This Service Information bulletin supersedes SI M17 08 12 dated January 2013.

Service Action: Retrofit of the Engine Coolant Temperature Sensor

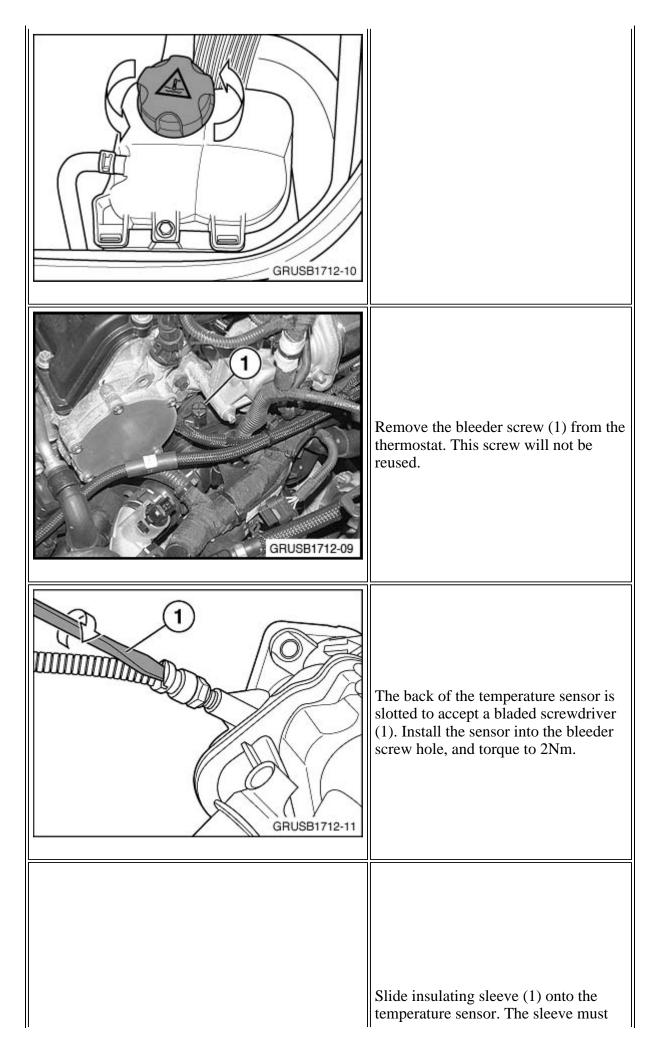
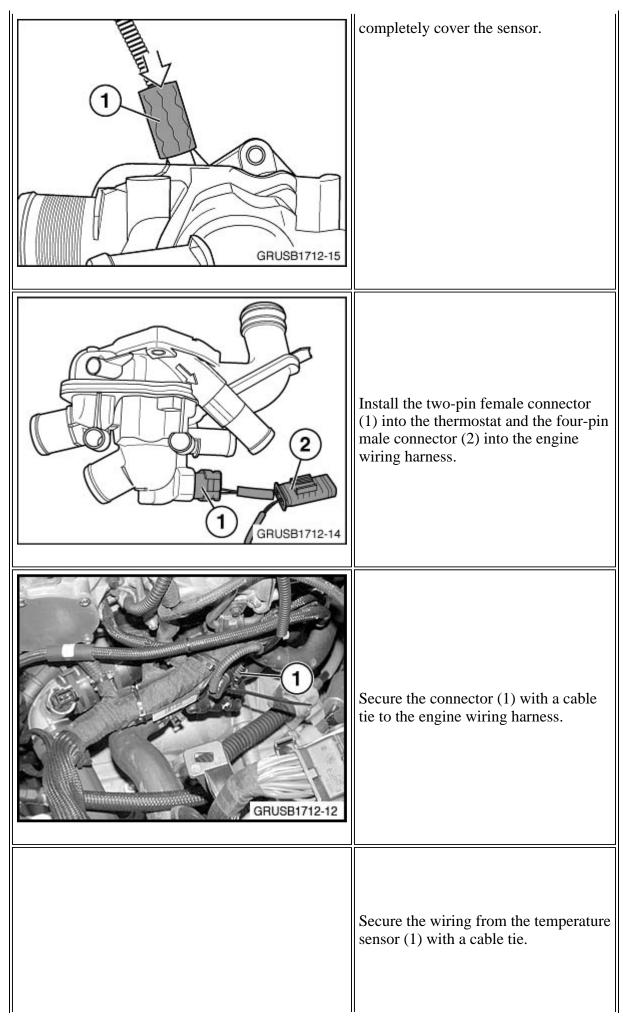
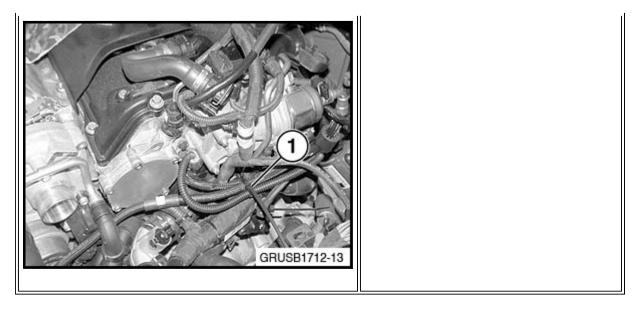
() () () () () () () () () ()	The improved sensor (P/N 13 62 8 603 908) includes the temperature probe (1) and insulating sleeve (2), a two-pin female connector (3) for the map thermostat, and a four-pin connector (4) for the engine harness.
	Relieve the coolant pressure by removing the reservoir cap, and then re-tighten.

Remove the fresh air intake tube and the charge air intake tube from the air box to the turbo to gain access to the engine harness at the thermostat.

Reinstall the intake components and vent/refill the cooling system (Repair Instruction 17 00 039).
